Overview: Production error in version 1.0 harnesses; The immobilizer wire (orange/black) is in pin position #4 instead of pin position #5. Although an effort to correct the issue was made, some quantity of harnesses did get shipped before the issue was spotted. We are advising to inspect the harness BLADE connector before attempting to install harness or program the module. This issue is not known to affect the version 2 harnesses, which require no modification.

Overview: Early versions of the FTI-STP1 harness require modification for **automatic transmission (AT)** applications, some of the product was able to be modified before release, but a small quantity was released without modification.

FTI-STP1: Vehicle Coverage and Preparation Notes

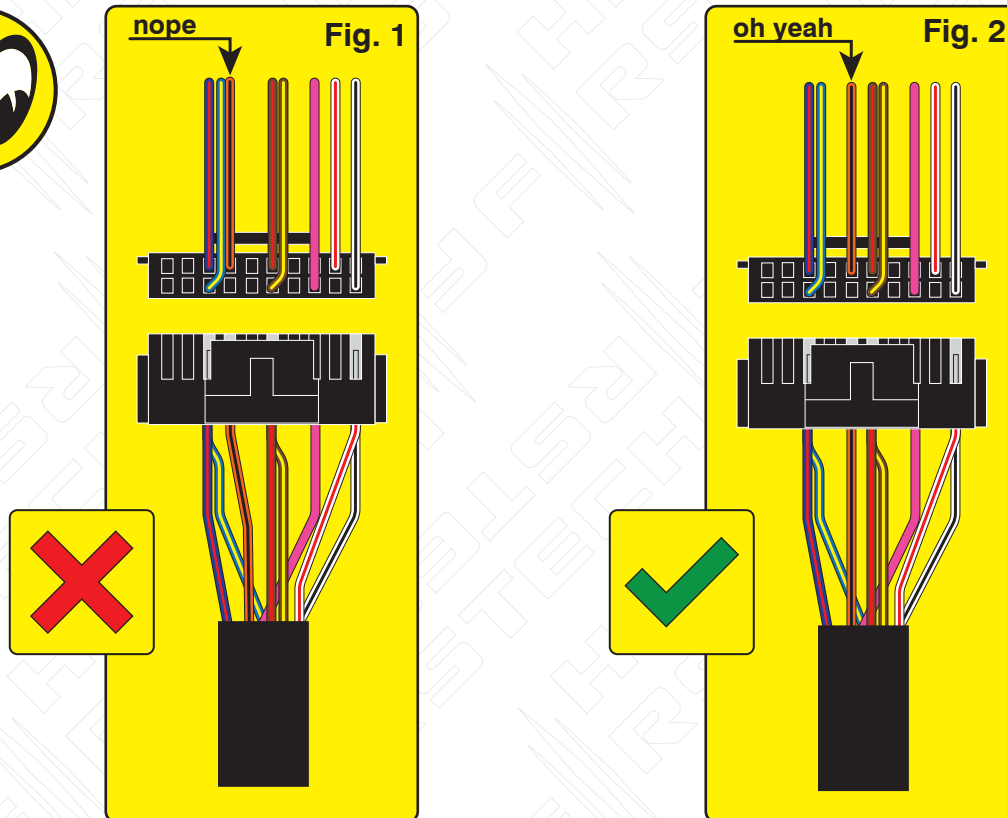
Issue: Module fails to program correctly to vehicle, does not allow the vehicle to be remote started.

Correction: Step 1.) Locate the orange/black wire and confirm whether it is positioned as illustrated in Fig. 1 or Fig. 2. If the wire is as illustrated in Fig.1, proceed with Step 2 through 5 and complete the repair procedure outlined, if the wire is as illustrated in Fig. 2, correction is not necessary, proceed with harness installation and module programming.

Step 2.) Using a pick, lightly depress the catch that secures the terminal in the housing then remove the wire and terminal from the housing.

Step 3.) Using a fine tip razor or utility knife, insert the blade beneath the terminal catch and raise it slightly, so that it can be reused to secure the terminal when reinserted into the BLADE connector housing.

Step 4.) Refer to Fig. 2 for correct position of the orange/black wire (next to brown/red) then reinsert the terminal, pressing lightly until the catch 'snaps' into place, securing the terminal in the connector housing.

MODIFICATION REQUIRED FOR A/T APPLICATIONS, ONLY WITH v 1.0 HARNESS

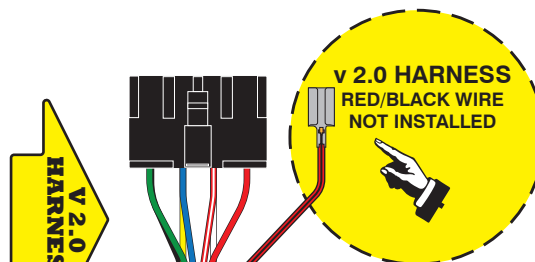
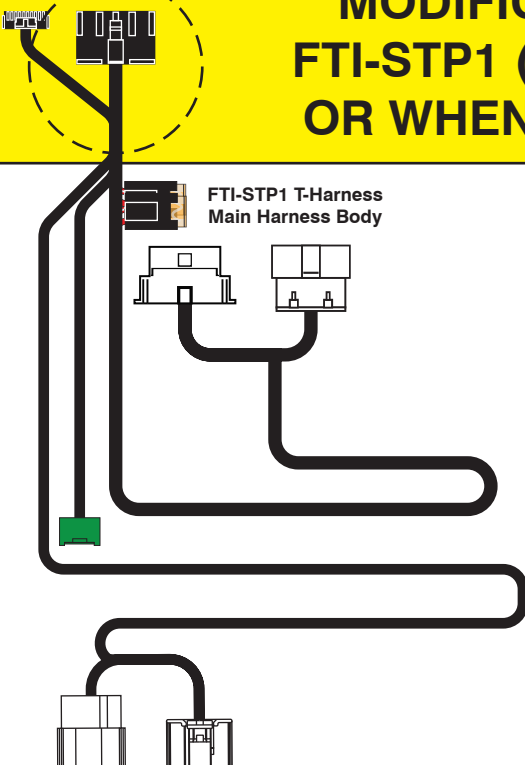
Issue: The FTI-STP1 T-harness has been designed to be compatible with A/T (automatic transmission) & M/T (manual transmission) applications, but due to an oversight in early production runs, the selection was defaulted to M/T mode.

Using a harness configured for an M/T application, in an A/T equipped vehicle, could result in vehicle module damage, it is advised that the harness be returned to A/T mode before installation in vehicles equipped with an automatic transmission.

Correction: Locate the **red/black (+ Clutch)** wire provided in the CN1 connector of the main harness assembly. Cut the **red/black** wire, either flush to the CN1 connector, or leaving enough wire exposed so that you can insulate and secure the ends of the wire that remain after cutting. Insulate each of the remaining ends of the **red/black** wire and secure to prevent any possibility of a short circuit. **If the red/black wire has already been disconnected, no further modification is required for A/T applications**
